Planning and Land Use Department Planning Commission Staff Report

Case Numbers	#2025-11028 #2025-11029 #2025-11030	
Hearing Date	November 6, 2025	
Agent	JenkinsGavin, Inc	
Applicant	Girls, Inc of Santa Fe	
Request	General Plan Amendment, Rezoning, Master Plan	
Location	2904 Rufina St, Santa Fe, NM 87507	
Case Manager	Alexa Hempel	
Current Zoning	Light Industrial (I-1), General Industrial (I-2), General Commercial (C-2)	
Overlay	Suburban Archeological Review District	
Pre-App Meeting	December 12, 2024	
ENN Meeting	July 23, 2025	
Proposal	Applicant requests approval of a General Plan Amendment to change the Future Land Use of a parcel, a Rezoning of a parcel from I-1 and I-2 to C-2, and a Master Plan for a youth center.

Case #2025-11030: 2904 Rufina Master Plan. JenkinsGavin, “Agent,” for Girls, Inc of Santa Fe, “Applicant,” asks the Planning Commission to recommend the Governing Body approve a Master Plan of a proposed youth center at 2904 Rufina St on Lots 3 and 2A, 2-2, totaling approximately 4.27-acres. Lot 3 is approximately 3.87-acres, and Lot 2A, 2-2 is approximately 0.399-acres and is located adjacent to the southwest side of Lot 3. (Alexa Hempel, Case Manager, anhempel@san

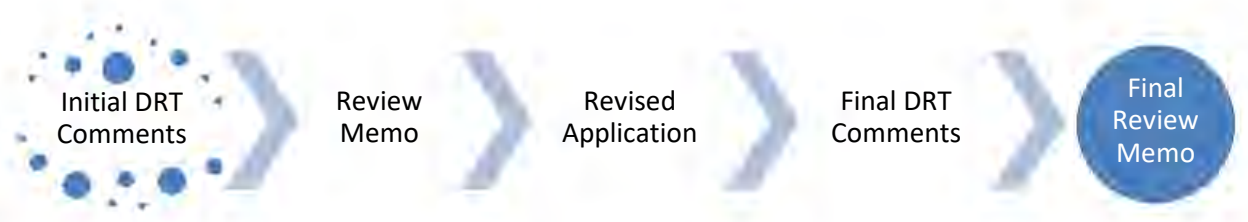
1. Notes on revised plans sheet C2 verify compliance with IFC 2021, Section 903, and Aerial Apparatus access road from 2 points of access to building.

PROPOSED SITE MASTER PLAN

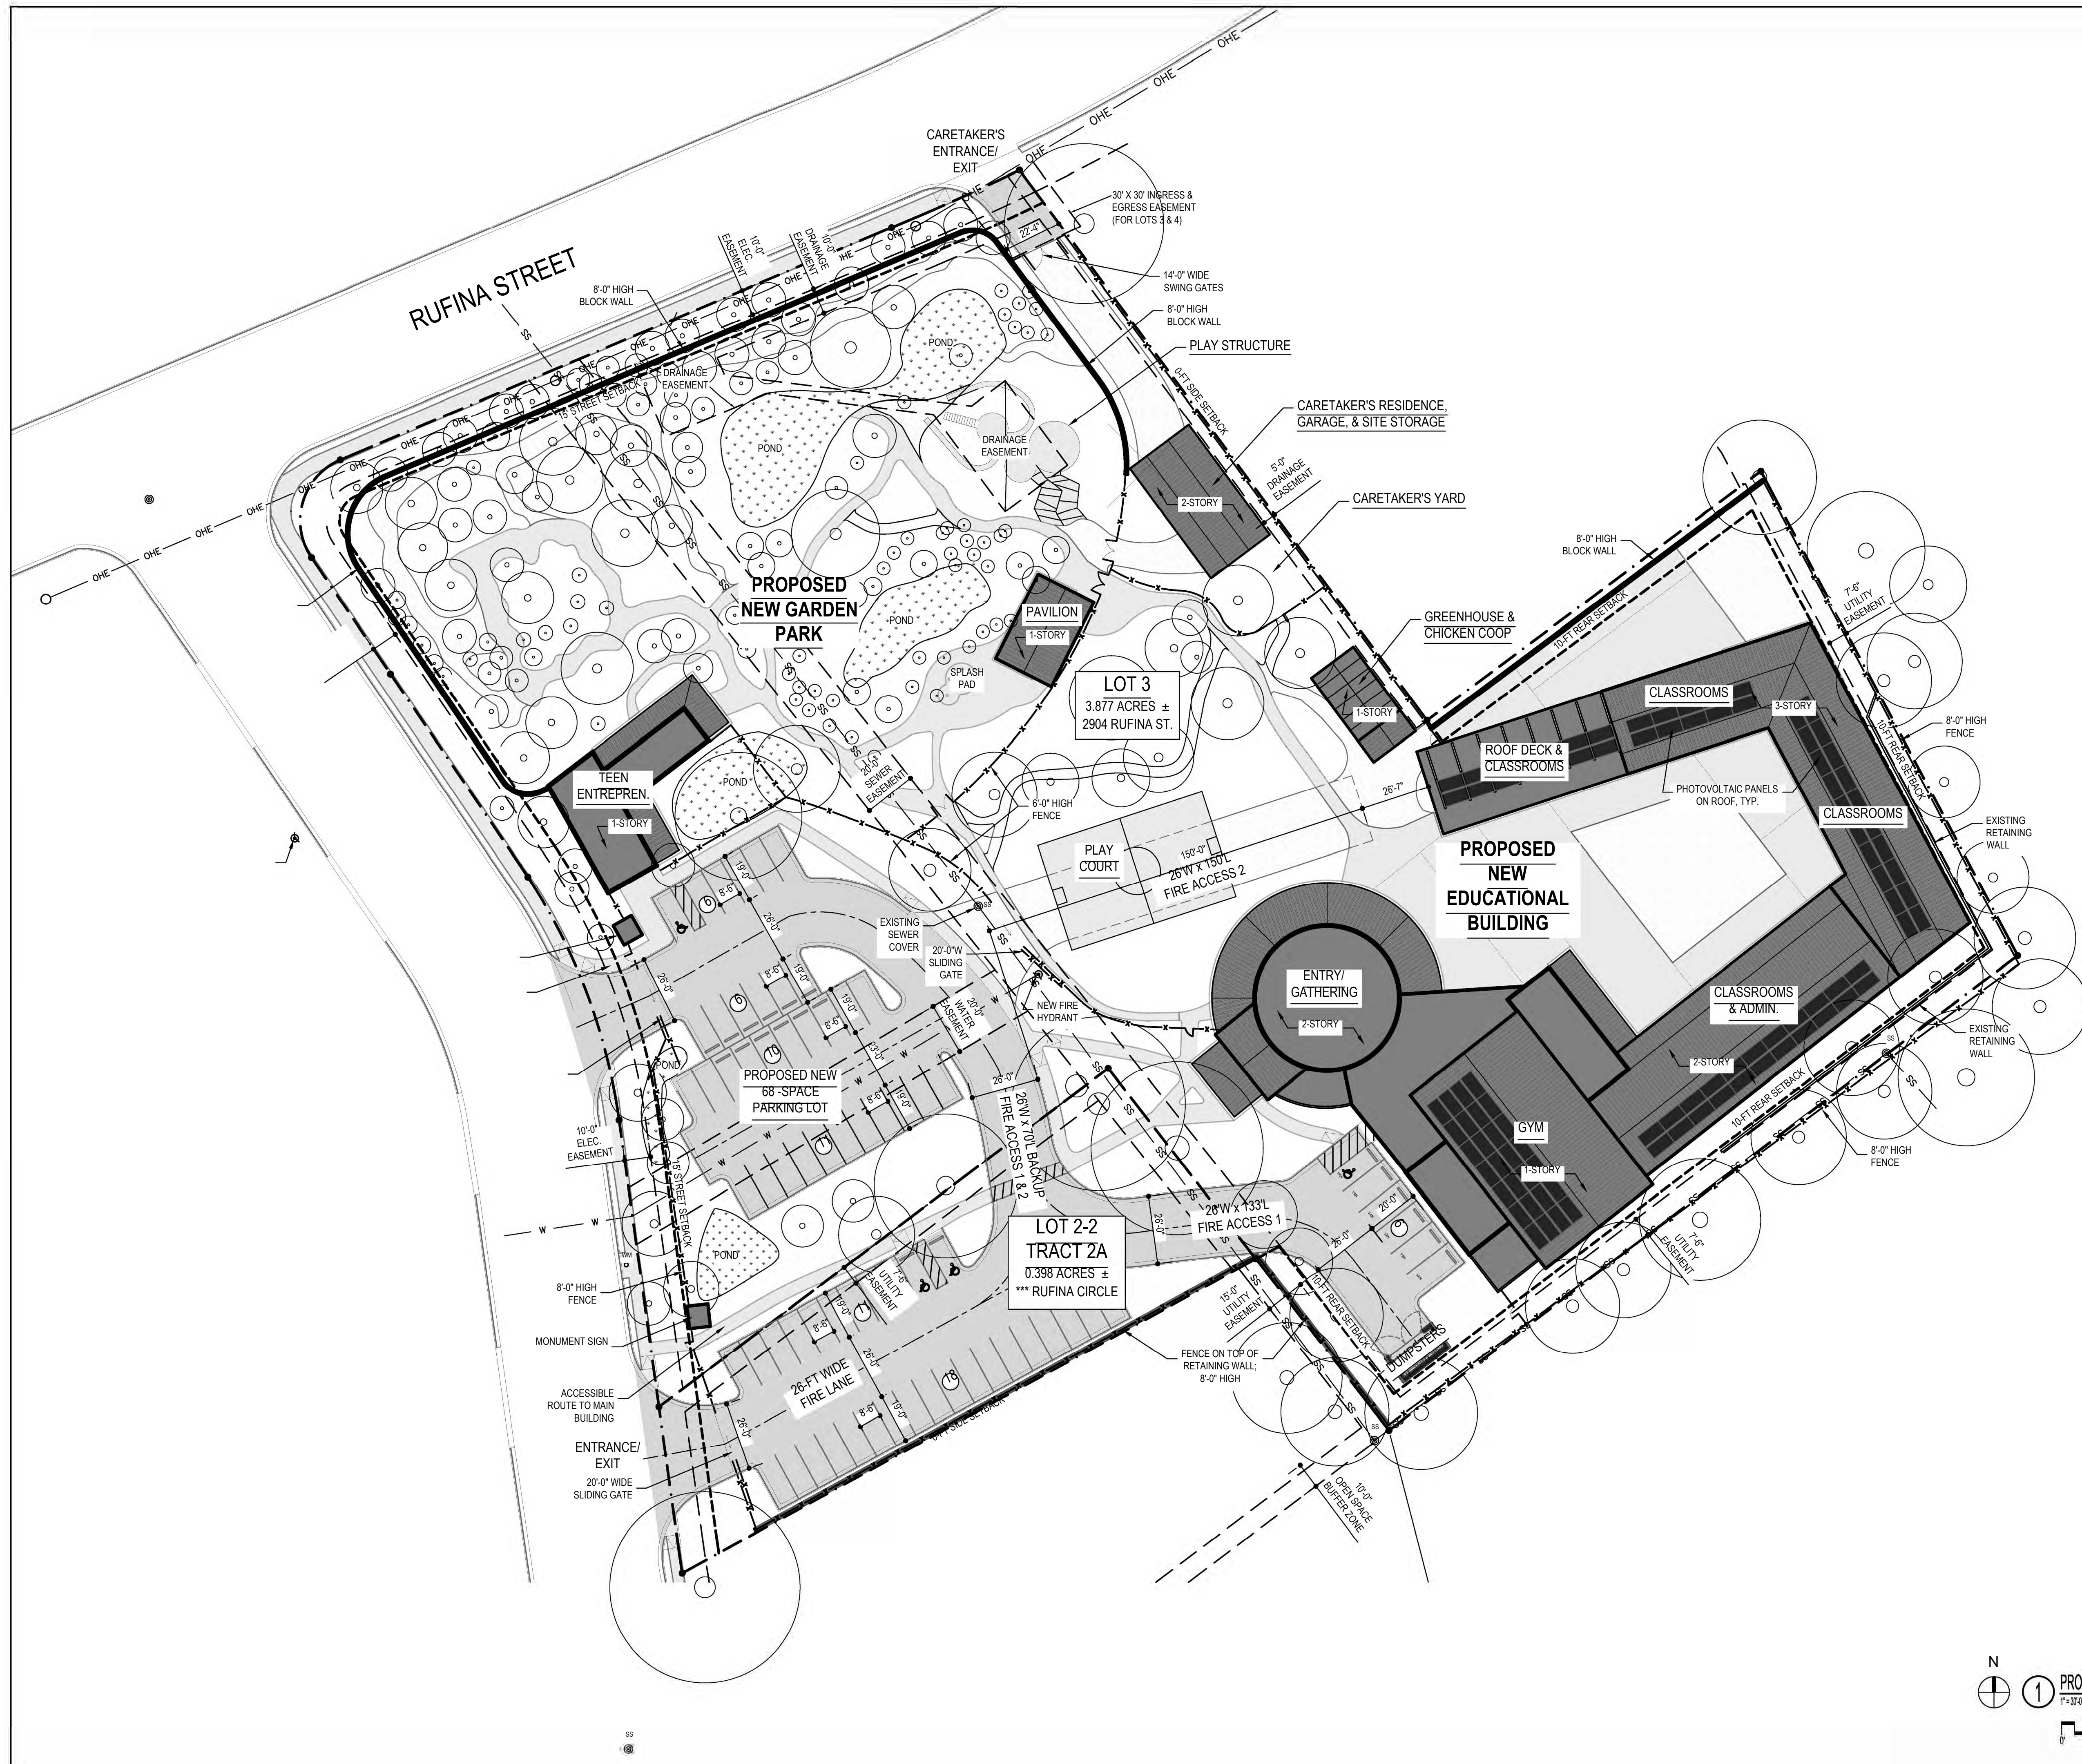
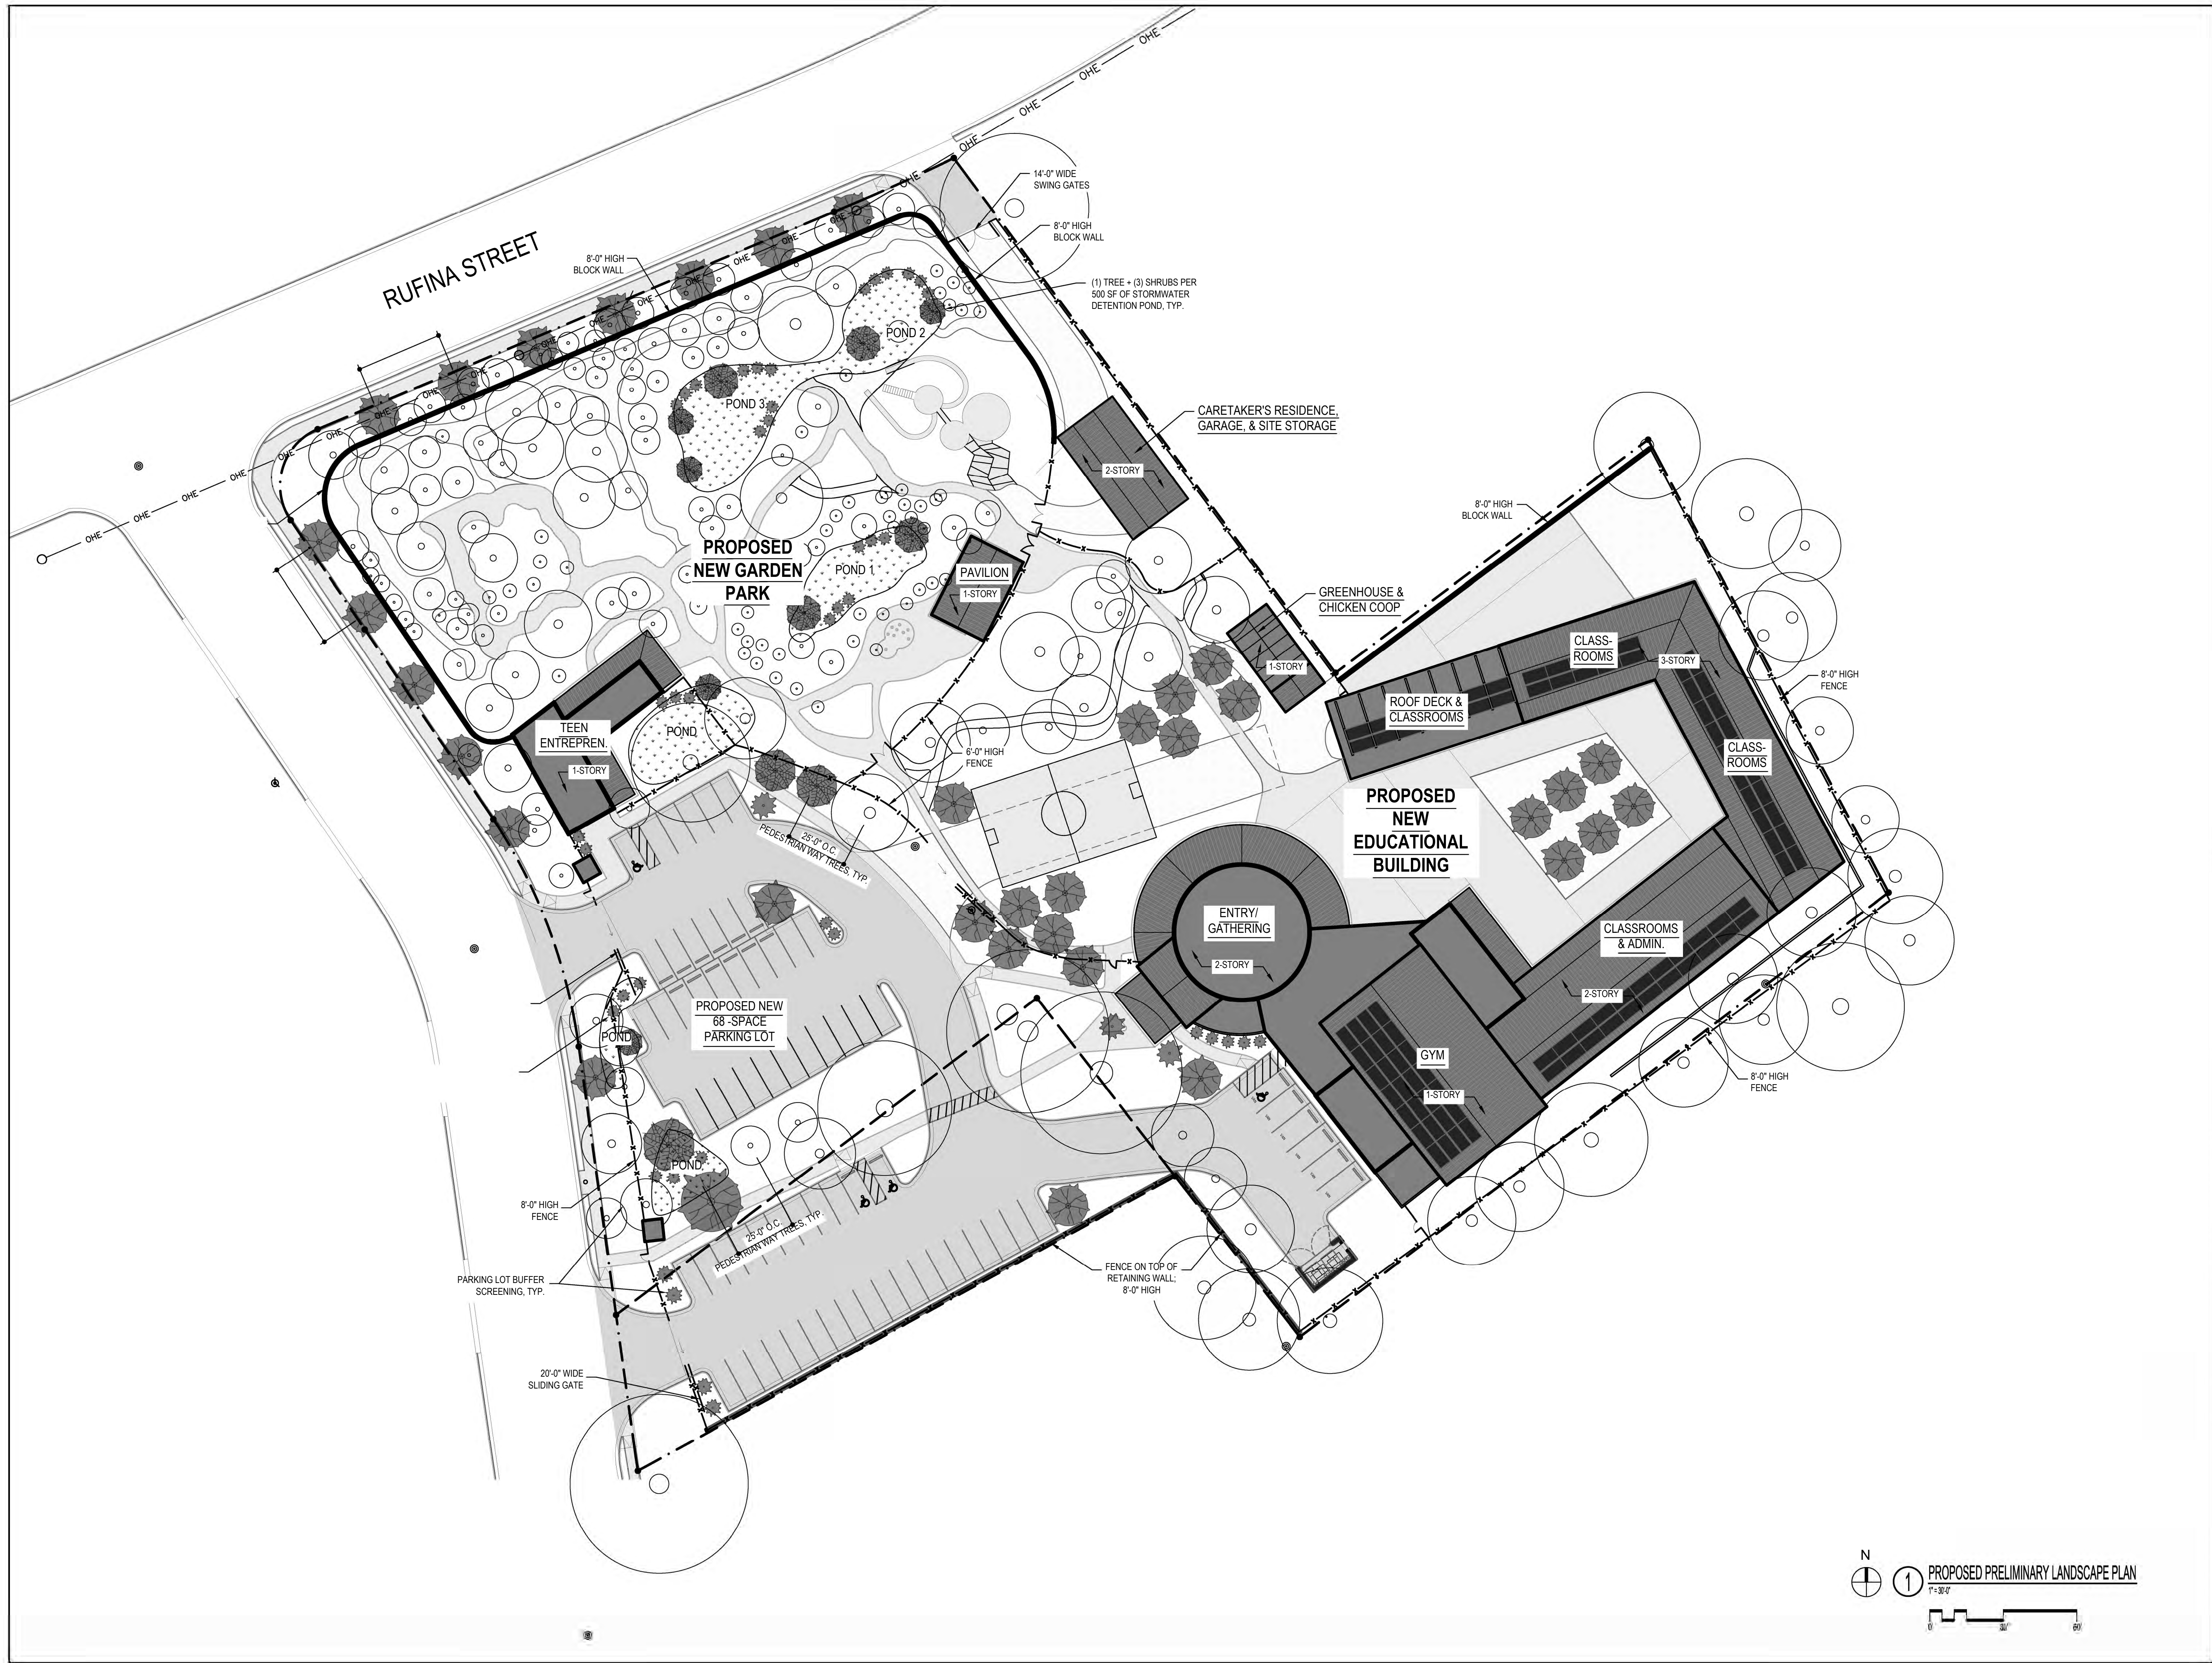
2	Add all textures/symbols used on Proposed Site Master Plan (Sheet C-2) into legend (ex: gravel texture, utility lines, log shaped drawings, etc)	Current Planning	Prior to public hearing (COMPLETED)
3	<p>Appropriate easements must be in place to cross between Lot 3 and 2-2 in perpetuity Applicant shall consolidate Lots 3 and 2A, 2-2 concurrent with Development Plan review or place appropriate easements between Lots 3 and 2A, 2-2 in perpetuity concurrent with Development Plan review.</p>	Current Planning	<p>Prior to public hearing Prior to development plan approval</p>
4	Add Case #2025-11030 to Master Plan sheets	Current Planning	Prior to public hearing (COMPLETED)
5	Shall comply with the most currently adopted International Fire Code	Fire	Prior to public hearing (COMPLETED)
6	Shall verify compliance with section 903 Automatic Sprinkler Systems of the IFC 2021	Fire	Prior to public hearing (COMPLETED)

1. Add all textures/symbols used on Proposed Site Master Plan (Sheet C-2) into legend (ex: gravel texture, utility lines, log shaped drawings, etc)
2. ~~Appropriate easements must be in place to cross between Lot 3 and 2-2 in perpetuity~~
3. Add Case #2025-11030 to Master Plan sheets
4. Submit a parking analysis at time of Development Plan
5. All utilities shall be underground

Conditions of Approval:	Must be completed by:	Applicant response**:
1. Add all textures/symbols used on Proposed Site Master Plan (Sheet C-2) into legend (ex: gravel texture, utility lines, log shaped drawings, etc)	Planning Commission. Complete	
2. Appropriate easements must be in place to cross between Lot 3 and 2-2 in perpetuity Applicant shall consolidate Lots 3 and 2A, 2-2 concurrent with Development Plan review or place appropriate easements between Lots 3 and 2A, 2-2 in perpetuity concurrent with Development Plan review	Planning Commission Development Plan. Applicant submitted affidavit acknowledging condition.	
3. Add Case #2025-11030 to Master Plan sheets	Planning Commission. Complete	
4.		
5.		
6.
